SERVICE INSTRUCTION

RUNNING MODIFICATIONS ON

ROTAX® ENGINE TYPE 912/914 (SERIES)

SI-912-020R9

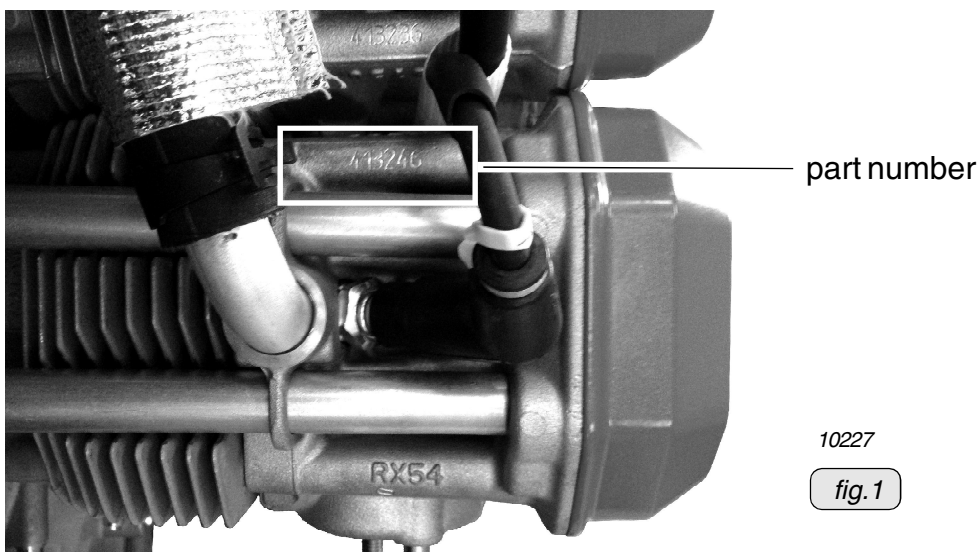
◆ **NOTE:** Identifying of new cylinder heads: The electrical connection of the temperature sensor is pointing upwards. New configuration see fig. 2. Old configuration see fig. 3.

Regarding change of position of the temperature sensor, see fig. 2 and fig. 3.

◆ NOTE: The temperature sensor part no. 965531 and its connection is not changed.

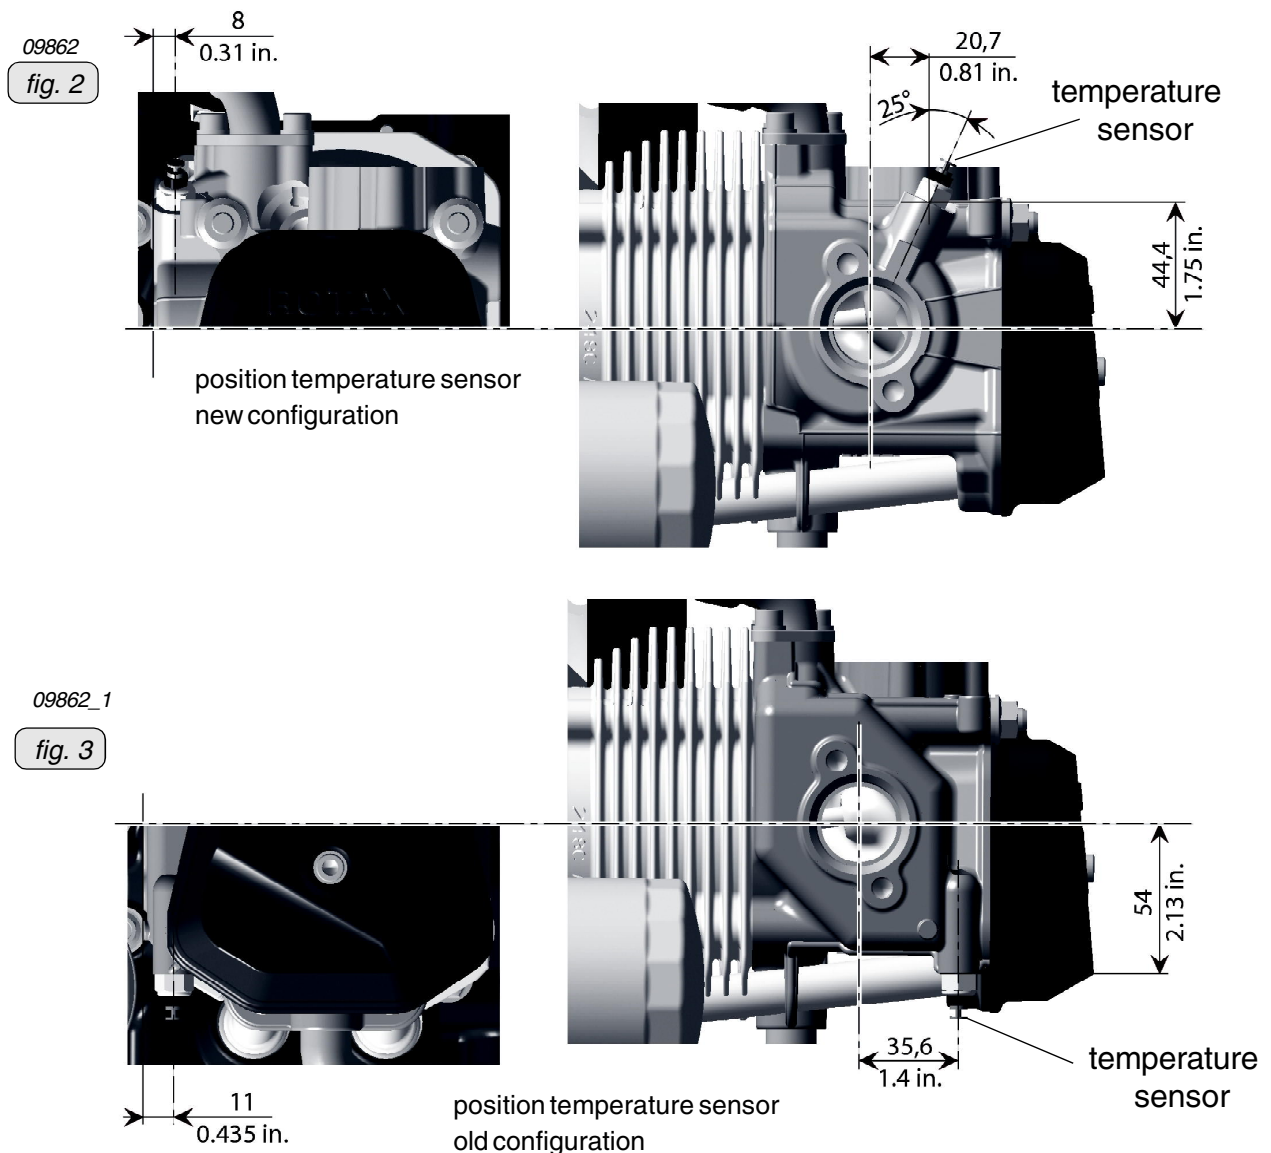
◆ NOTE: Contrary to the current design, the temperature sensor is directly flooded with coolant. Therefore the thread must be sealed with LOCTITE.

1. Clean the thread of the temperature sensor.
2. Apply LOCTITE 243 to the thread of the temperature sensor. Tightening torque 10 Nm (90 in.lb).
3. Plug the respective wiring harness connector into the temperature sensor.
4. Engine assembly.
5. Fill with operating fluids (coolant, oil or fuel). See also chapter 12-20-00 current issue of Maintenance Manual Line for the engine type 912/ 914 Series.
6. Conduct test run. See also chapter 12-20-00 current issue of Maintenance Manual Line for the engine type 912/ 914 Series.

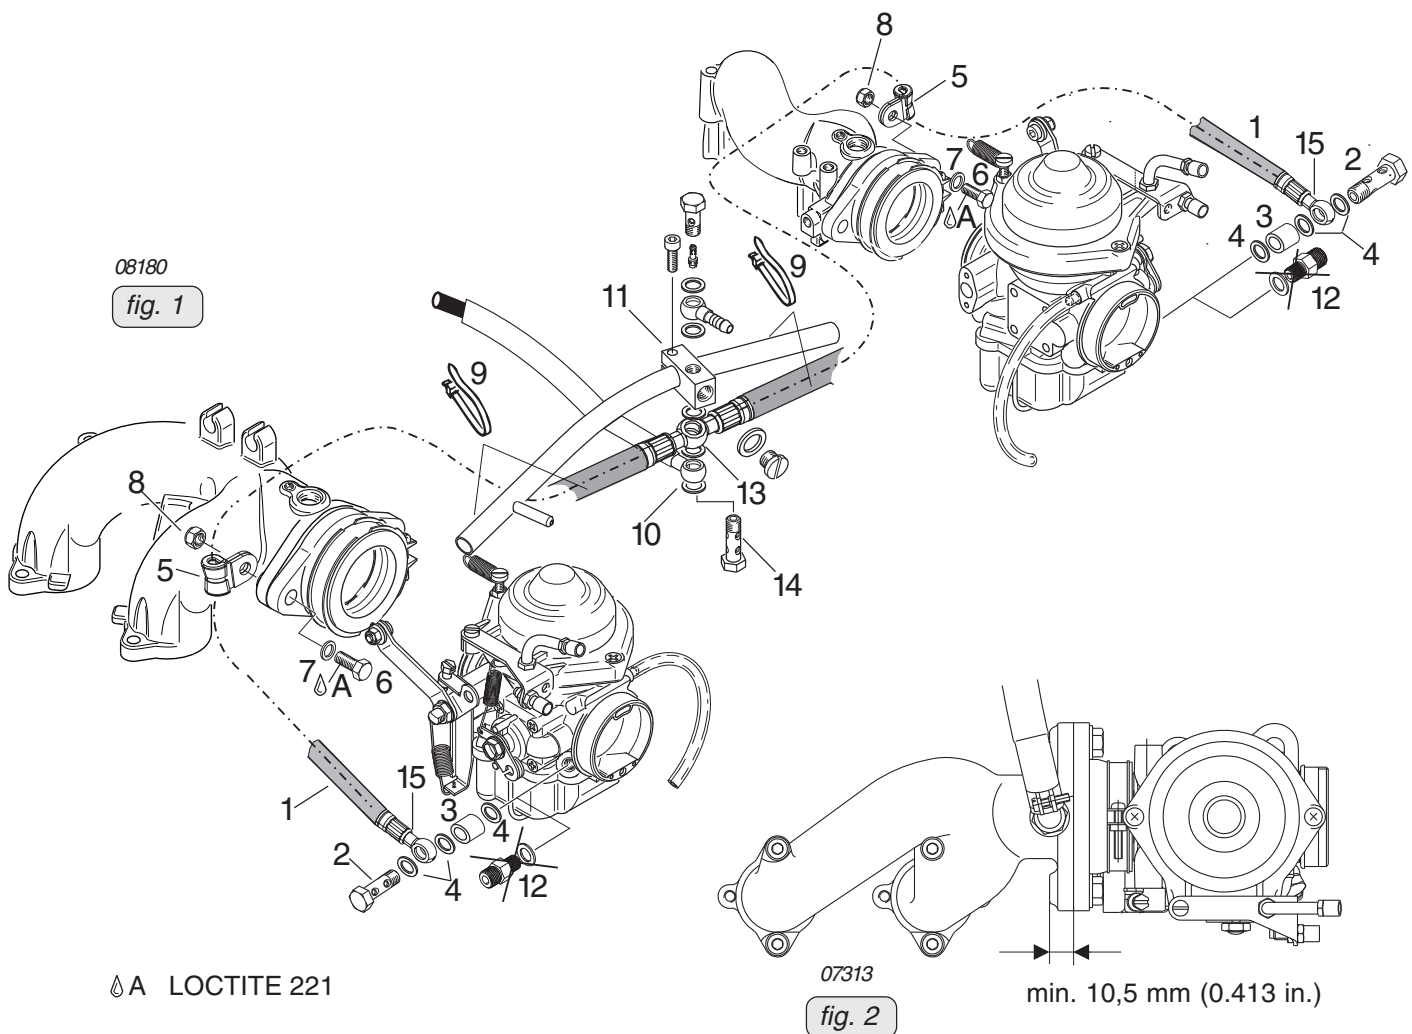
In the course of continuous development and for better assembly and maintenance a new flexible fuel line (part no. 874911) has been introduced.

Installation of this new fuel line requires the following modifications:

- mechanical machining at the intake manifold for the attachment of the cable clamp. At engine repair/general overhaul be aware that the fixation of the flexible fuel line needs an appropriate contact surface. If necessary replace the intake manifold or machine the contact surface according to the following instruction.

- Install the flexible fuel line (1) with the double ring hose nipple (13) and sealing ring (10) on the clamp block (11). Tightening torque of banjo screw (14) 10 Nm (90 in. lb.) (see fig. 1).

- Install the ring hose nipple (15) with distance sleeve (3) and sealing ring (4) on the carburetors. Tightening torque of banjo screw (2) 10 Nm (90 in. lb.)

- For installation on an old style intake manifold perform the following: Remove the intake manifold and machine the nut/clamp contact area until the surface is parallel with the sealing surface of the carb socket. The thickness of the material must not be dressed down less than 10,5 mm (0.413 in.) and should be smooth and flat so that the nut/clamp assembly has an even contact surface (see fig. 2).

- Ensure proper support of the flexible fuel line. Install Hex. screw (6) and washer (7) with 15 Nm (133 in. lb.). Install the cable clamp (5) at the hex. screw (6) of the carburetor socket with the hex. nut (8). Tightening torque of hex. nut (8) 24 Nm (213 in. lb.)

08353
fig. 1

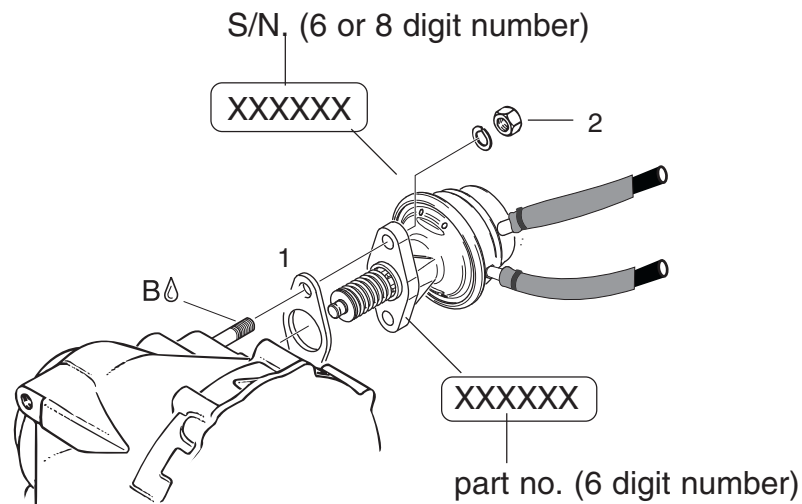
In the course of continuous development a new gasket (1) (part no. 950226) has been introduced.

The gasket is interchangeable.

- ◆ NOTE: On the sealing surfaces of the gearbox housing and the fuel pump no sealing compound has to be used.

fig. 1

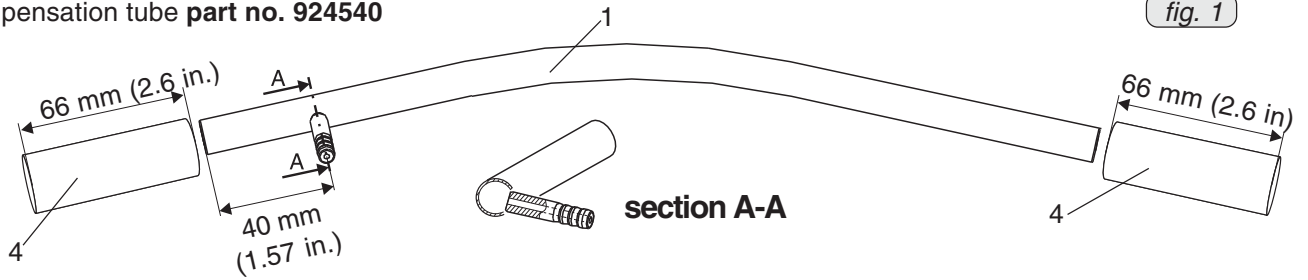
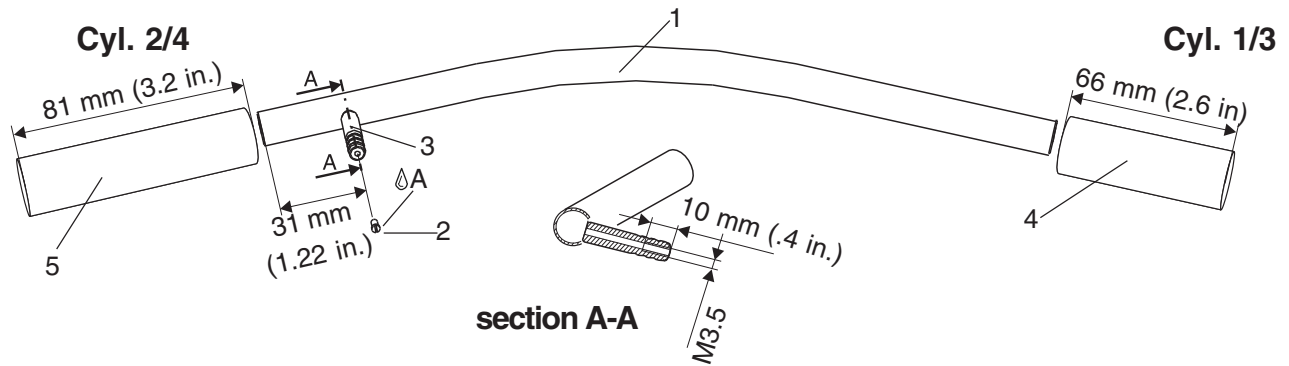
In the course of continuous development a new compensation tube (1) (part no. 924541) has been introduced which the synchronization to make it easier, the tube must not removed.

- position of connection fitting (3) on compensation tube remains approximate constant
- additional screw (2) part no. 940980 for connection fitting (3)
- new tube (4) part no. 956143 (5) part no. 956141

- ◆ **NOTE:** In case of interchangeable it is not possible to exchange individual parts. The new compensation tube are only **together** interchangeable with the tube part no. 956141. In case of spare parts the relevant configurations must be observed.

fig. 2

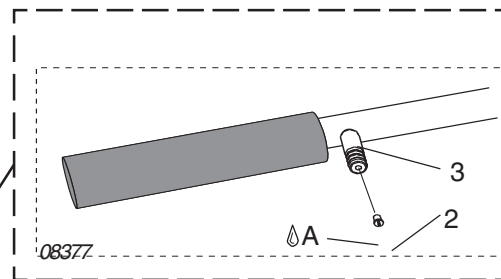
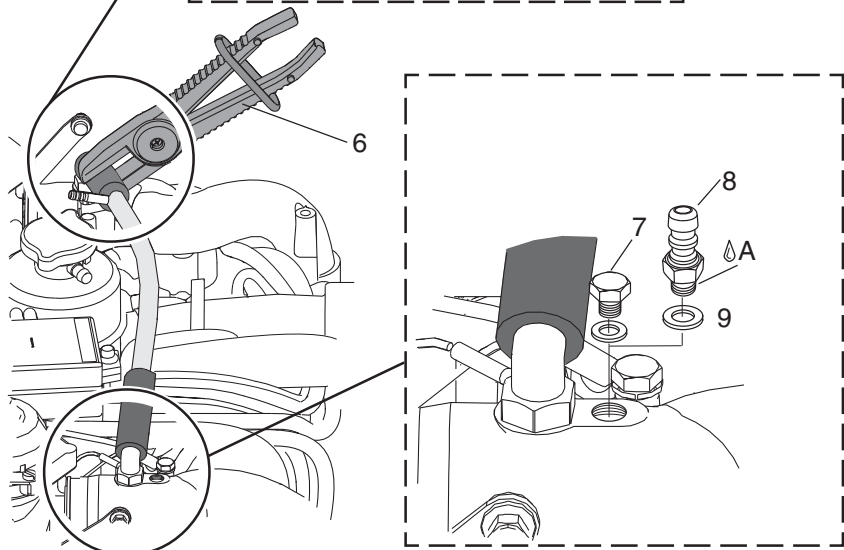
The two carburetors are adjusted to equal flow rate (mechanical or pneumatical synchronisation) has to be performed in accordance with the relevant Maintenance Manual ROTAX® 912/914 and following changes must be observed:

1. Install the vacuum gauge.
2. Clamp the tube with hose clamping pliers (6). Observe the position! The tube (1) must not removed.
3. Unscrew the screw (7).
4. Install the hose nipple M6 (8) with the sealing ring (9).
5. After synchronization tightened the screw M6x6 (7) with LOCTITE 221.

fig. 1

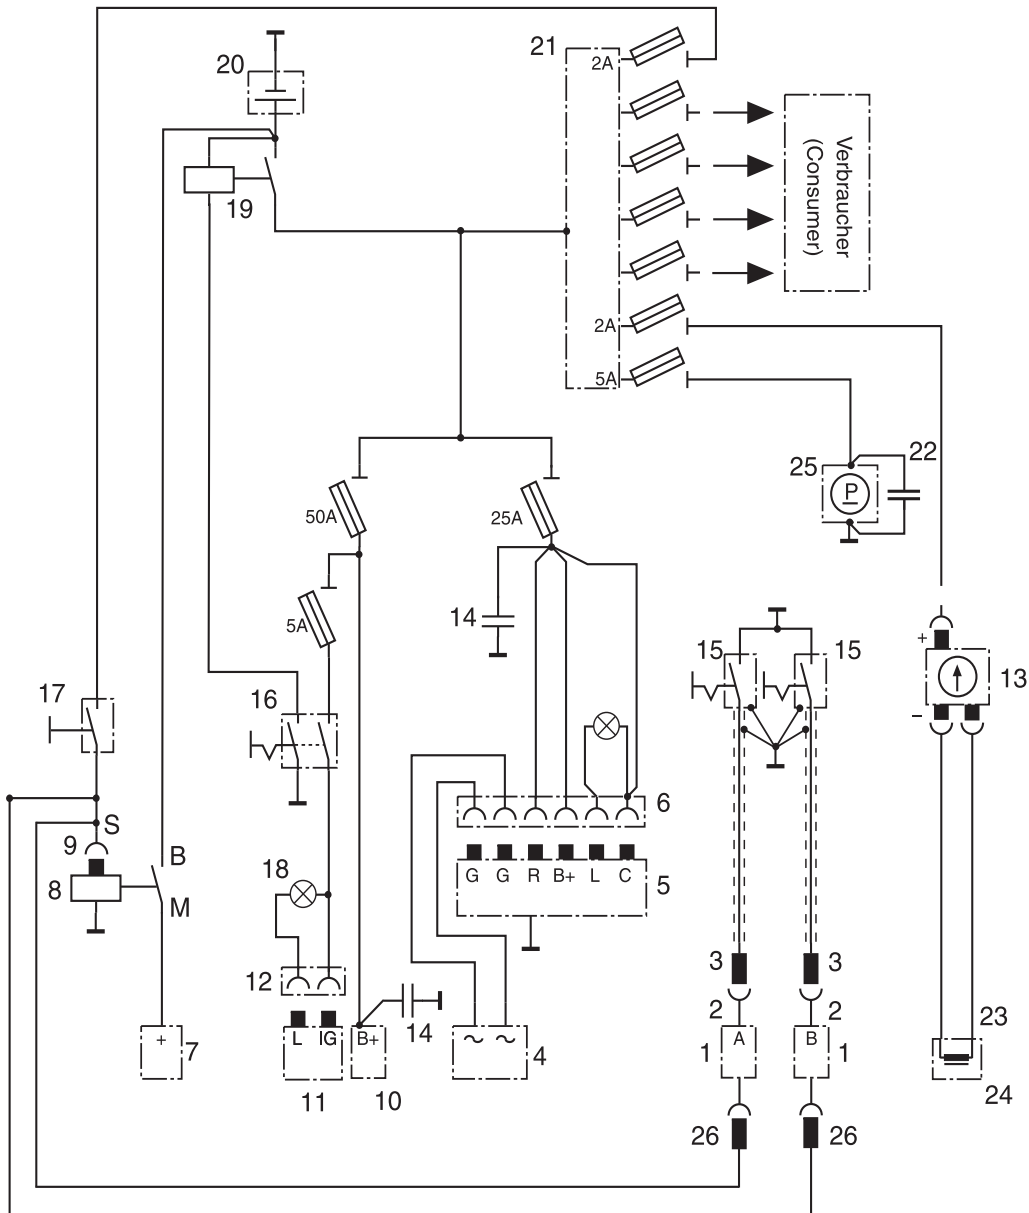
In the course of further development and standardization an electronic module for delayed start up ignition timing has been introduced. This module can be activated by a 12 V signal. Without this optional 12V activation the function works the same way as on the well-proven previous module.

- 1 wire of each module circuit A and circuit B (6-pole) to start relay control signal wire (see position 26 in fig. 1) must be supplied by the aircraft manufacturer. Therefore the rubber plug of the pin terminal must be removed before!
- Time factor for delaying ignition timing at start until switching to advanced ignition: After starting the engine and as soon as the starter/relay is not powered anymore, the engine continues to further run for 3-8 seconds with delayed ignition.
- Do not connect the signal wire to the electric starter motor - as the circuit has not voltage protection.
- Do not power the advanced start terminal permanently with 12V. The delay timer function would be bypassed and charging speed might vary (depending on internal tolerances, trigger gap etc.).
